SYSTEM/MODEL: LEF

MODIFICATION: Eliminate incoming call tone from sub station at master

REFERENCE DRAWING #: 0998-1305, 1180~1182-1305

LEF-3 Schematic Diagram

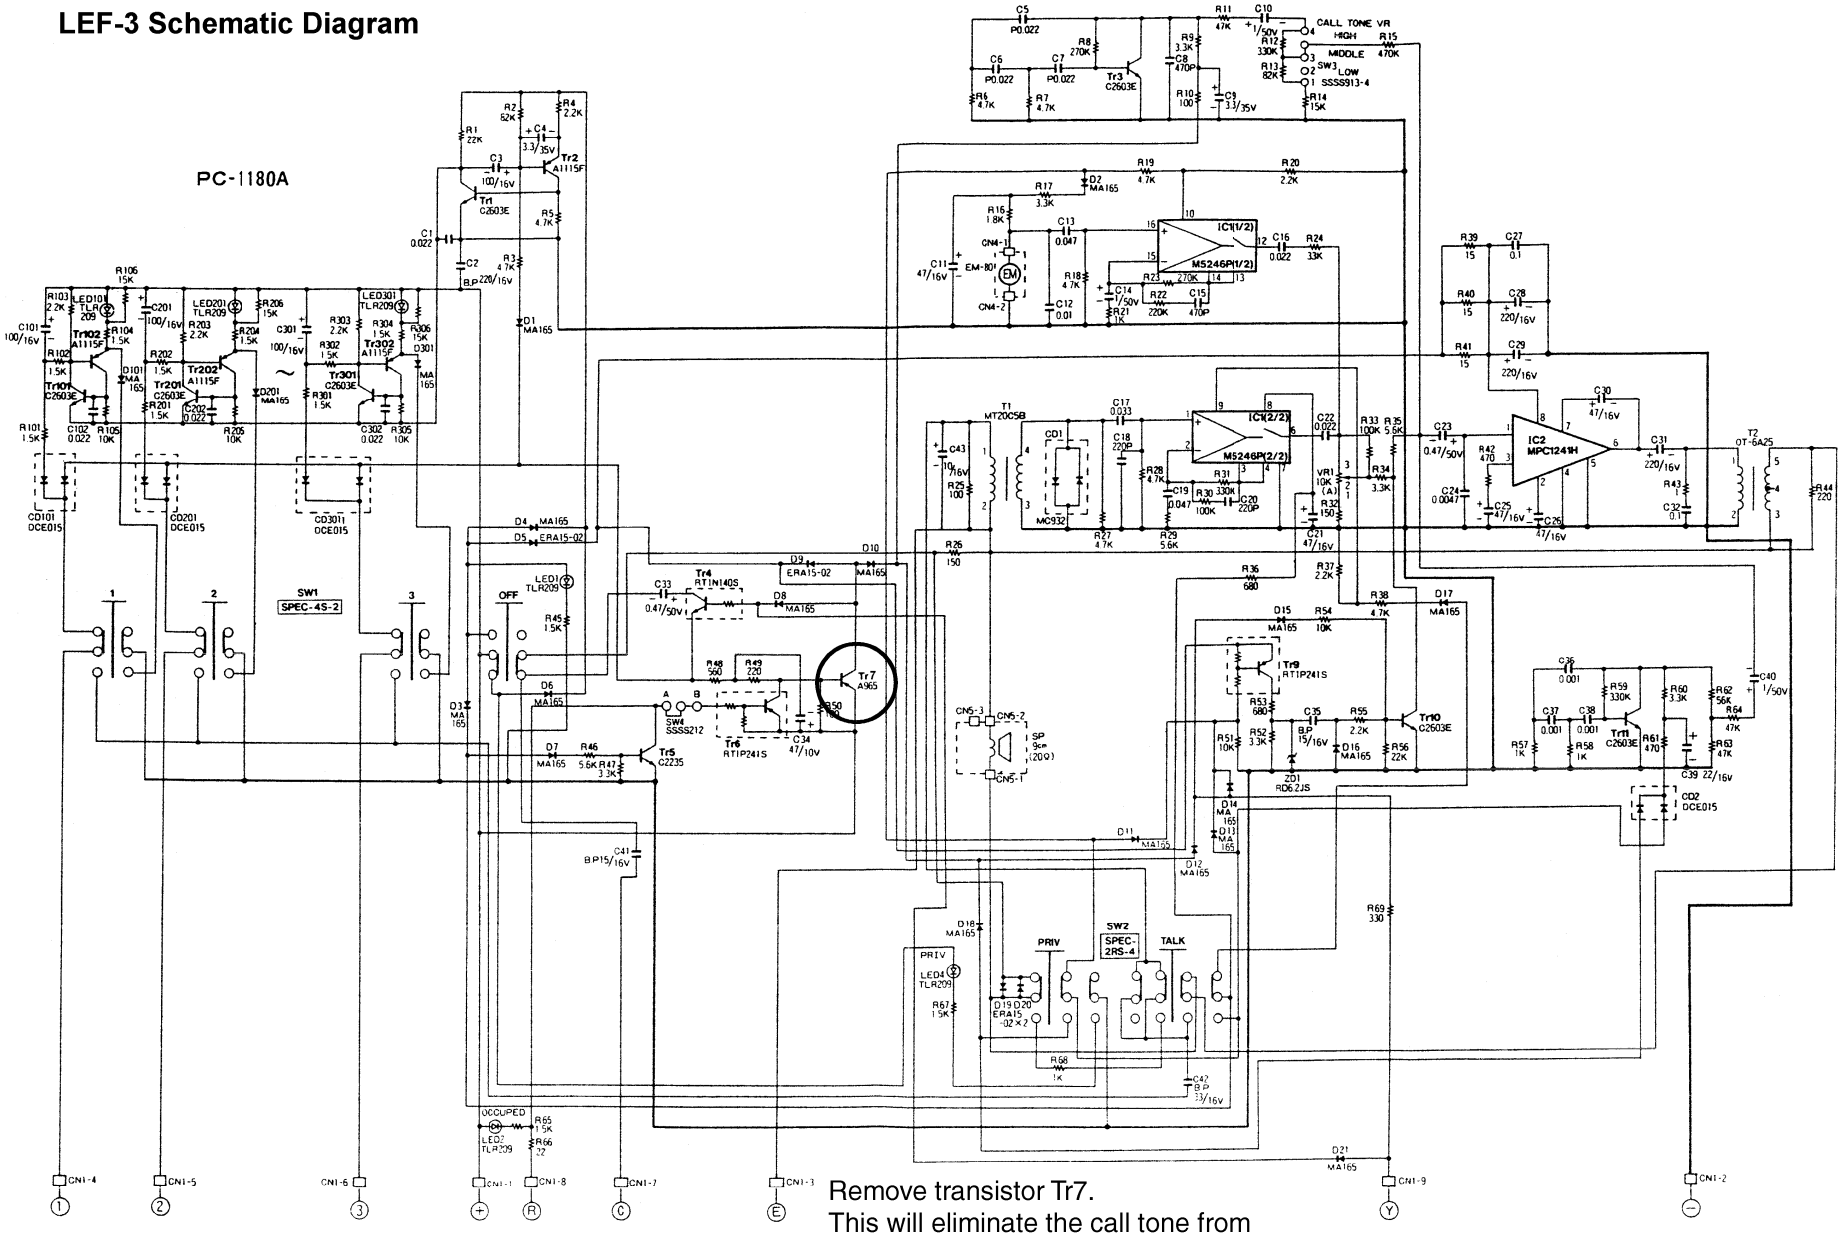
Remove transistor Tr7.
This will eliminate the call tone from being heard when a remote station calls.

LEF-5 Schematic Diagram

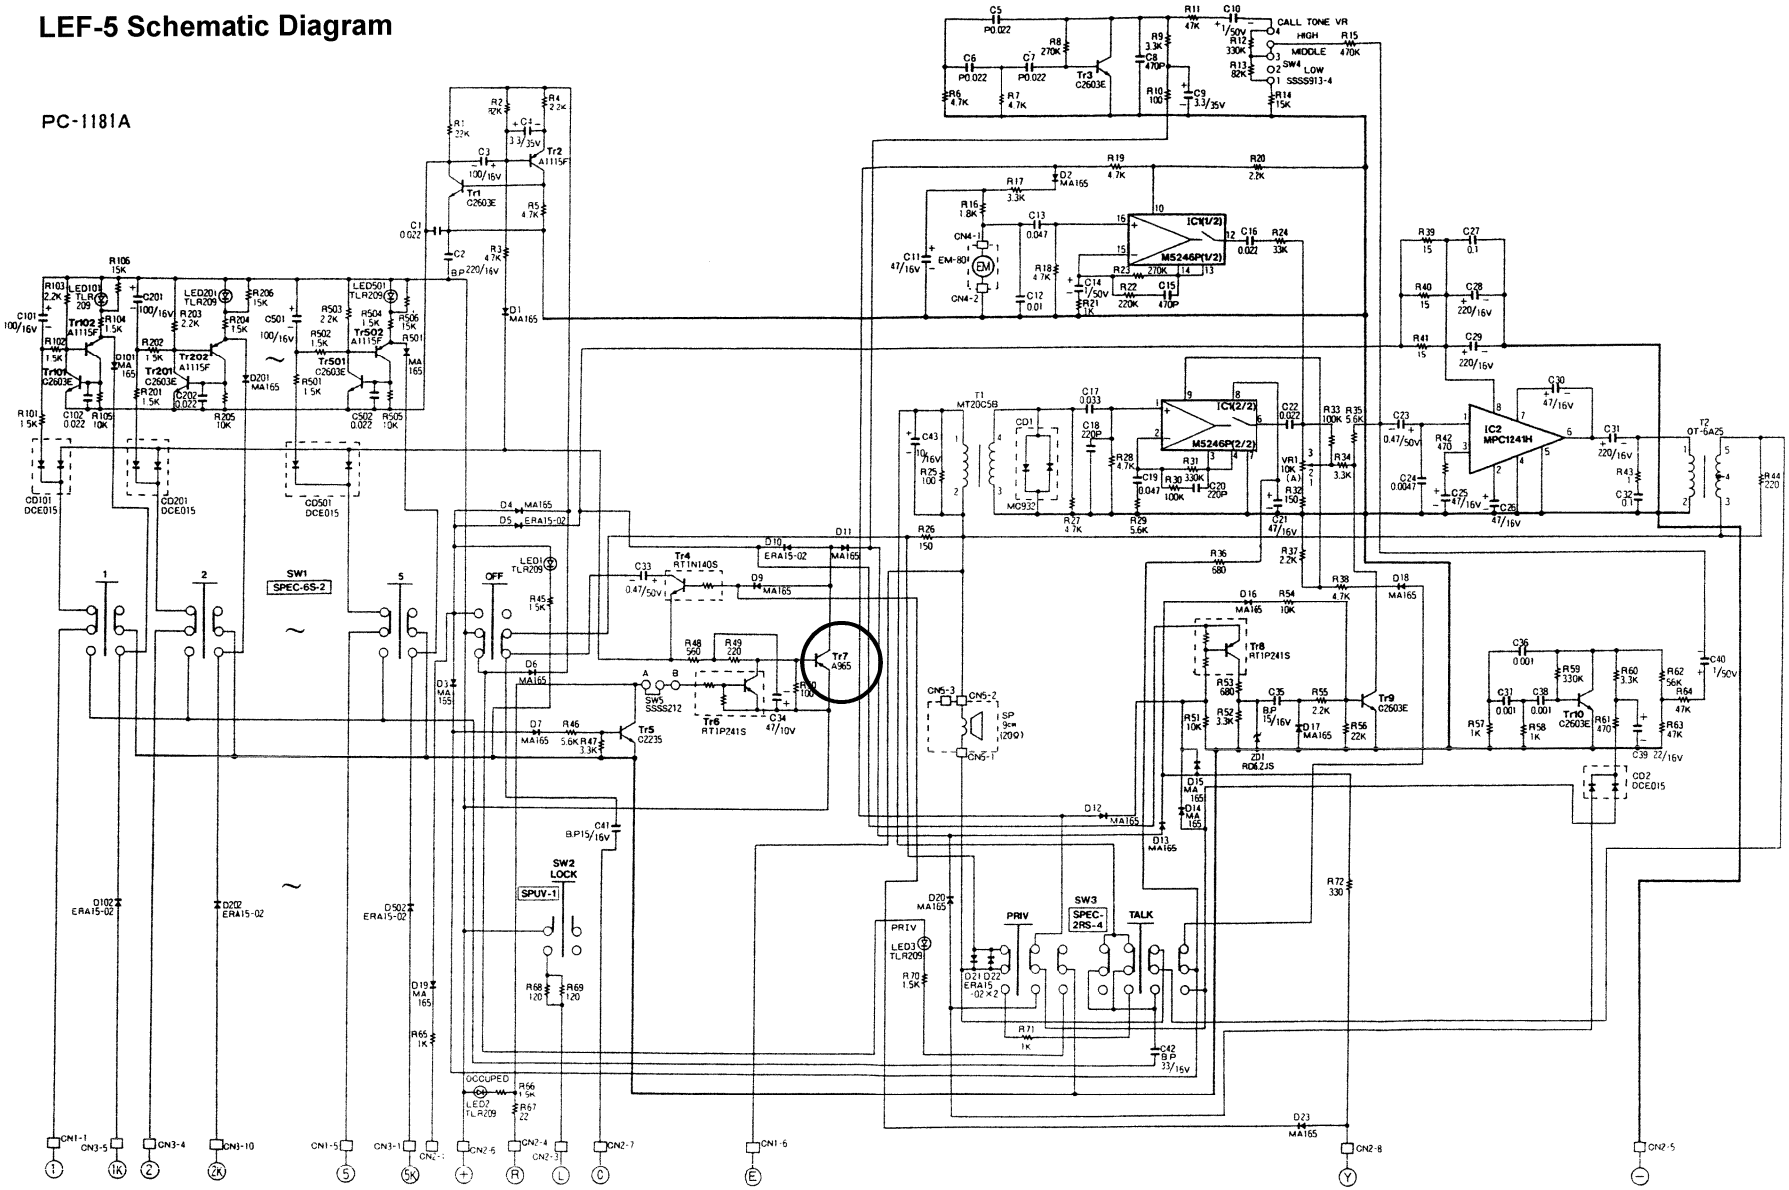
Remove transistor Tr7.
This will eliminate the call tone from being heard when a remote station calls the master station.

LEF-10 Schematic Diagram

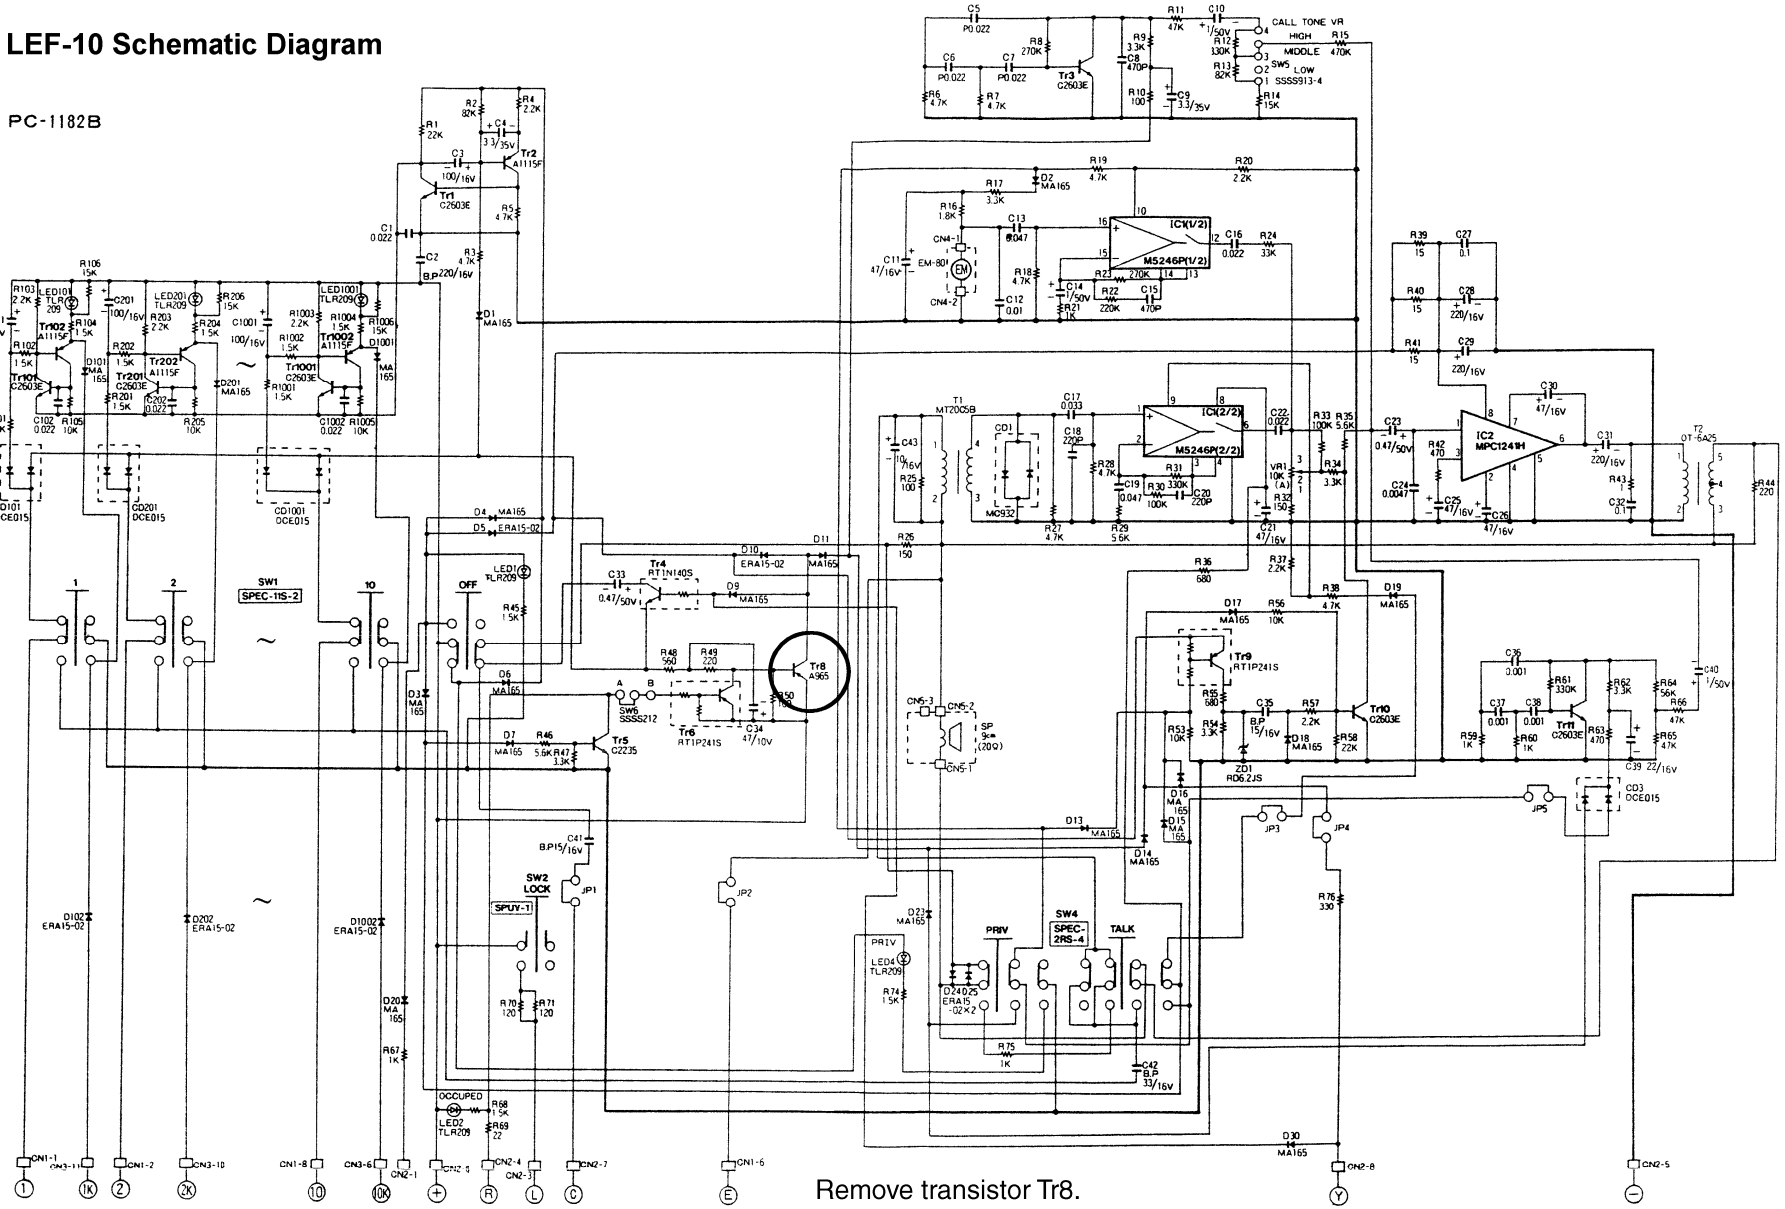
Remove transistor Tr8.
This will eliminate the call tone from being heard when a remote station calls the master station.
